ADDENDUM

PROJECT NAME Huber Heights Tenant Fit Out (Phase 2)

LWC COMMISSION NUMBER 24618.00

ADDENDUM NUMBER A-002

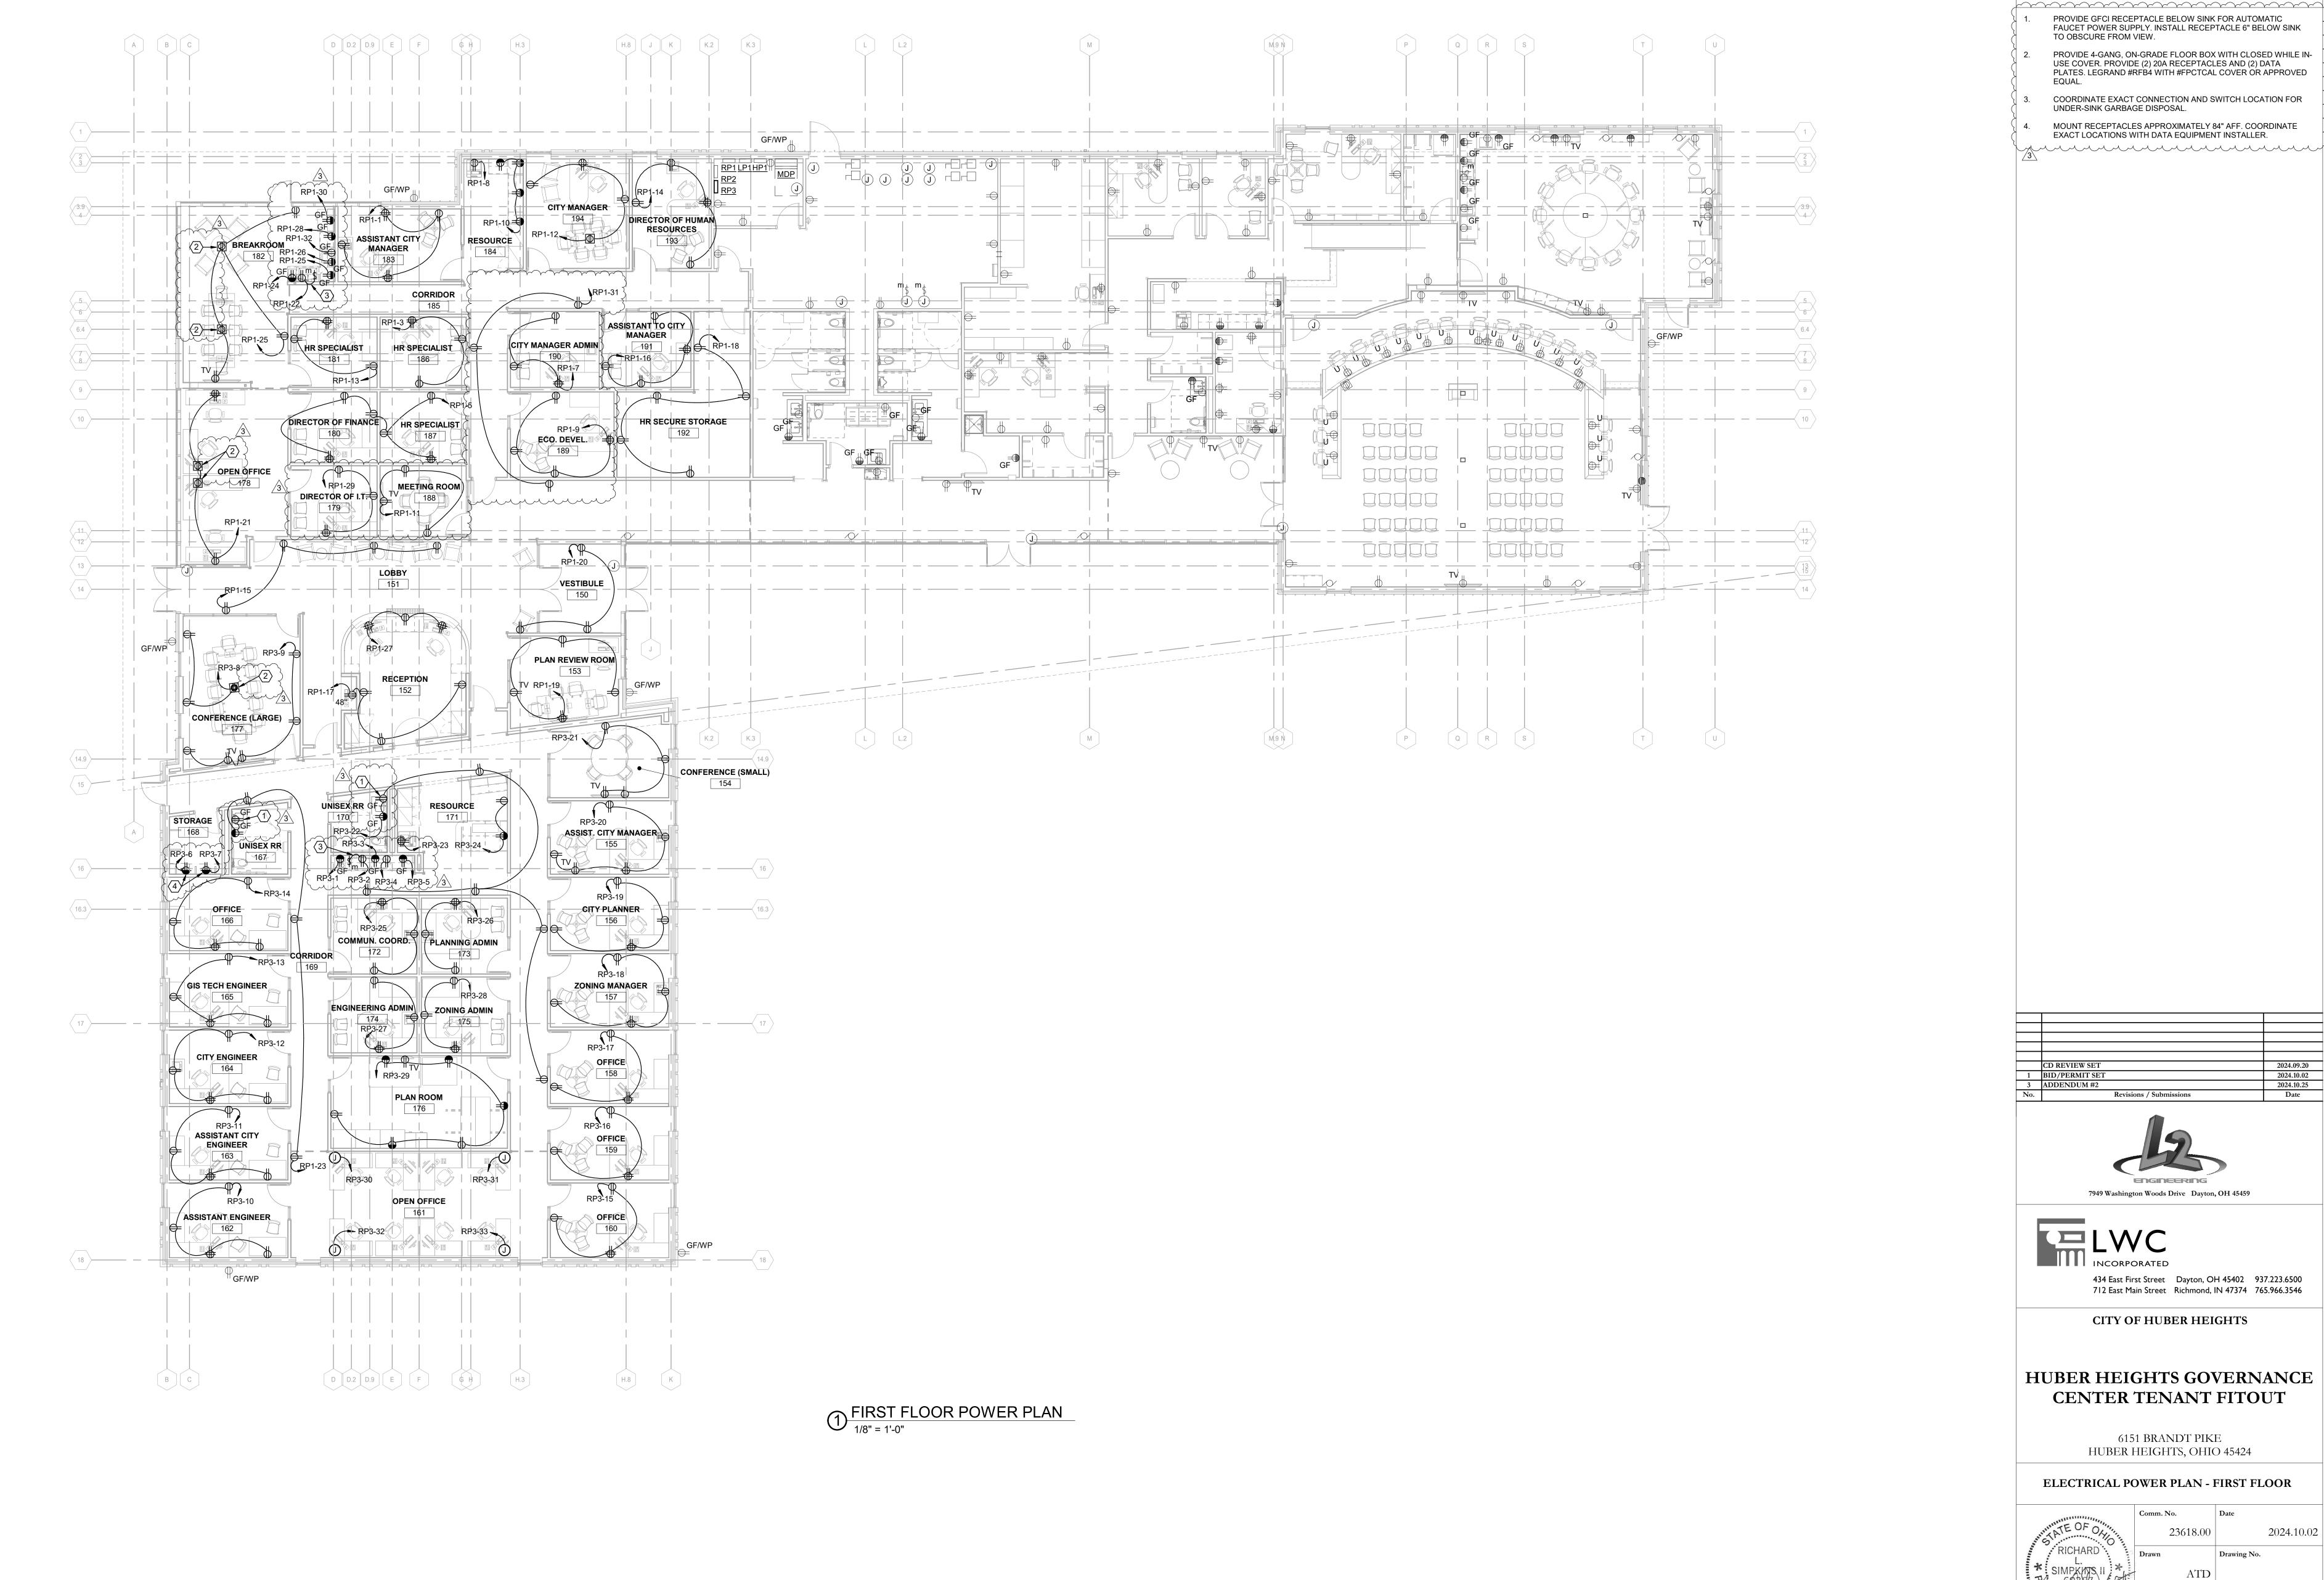
22	then hang and finish. If the shell contractor hangs the walls a different GC would have to include for cut and patch money that the shell contractor would not have. The drawings appear to show walls at the perimeter of the building. Are these walls already in place by the shell contractor or should they be included in the GC scope for this phase?	Please refer to Phase 1 docs.
23	Please confirm the exterior windows (by shell contractor) do not have new windowsills. If they do need sills, please provide details.	Please refer to Phase 1 docs.
24	Please provide a mounting detail for the roller shades.	The Mecho Shades should be installed between the curtainwall system jambs similar to below with snaploc L fascia matching the curtainwall finish.
